Well Name: AXI APACHE A	Well Location: T23N / R5W / SEC 9 / NWNW / 36.244237 / -107.372235	County or Parish/State: RIO ARRIBA / NM
Well Number: 6	Type of Well: CONVENTIONAL GAS WELL	Allottee or Tribe Name: JICARILLA APACHE
Lease Number: JIC77	Unit or CA Name:	Unit or CA Number:
US Well Number: 3003905121	Well Status: Gas Well Shut In	Operator: DJR OPERATING LLC

Notice of Intent

Type of Submission: Notice of Intent	Type of Action: Plug and Abandonment
Date Sundry Submitted: 01/24/2022	Time Sundry Submitted: 09:36
Date proposed operation will begin: 01/24/2022

Plug and Abandonment Procedure
for
DJR Operating, LLC
AXI Apache A 6
API # 30-039-05121
NW/NW, Unit D, Sec. 9, T23N, R5W
Rio Arriba County, NM

Current Wellbore Diagram
DJR Operating, LLC
AXI Apache A 6
API # 30-039-05121
NW/NW, Unit D, Sec 9, T23N, R5W
Rio Arriba County, NM

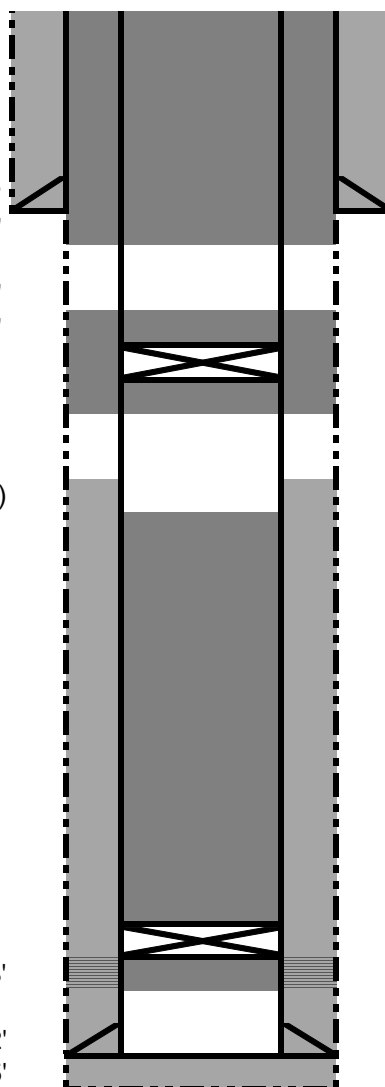
You are also required to place cement excesses per 4.2 and 4.4 of the attached General Requirements.

- The plugs proposed in the P&A procedure will adequately protect any freshwater sands in this well bore.
- Pictured Cliffs perms 2067' – 2113'.
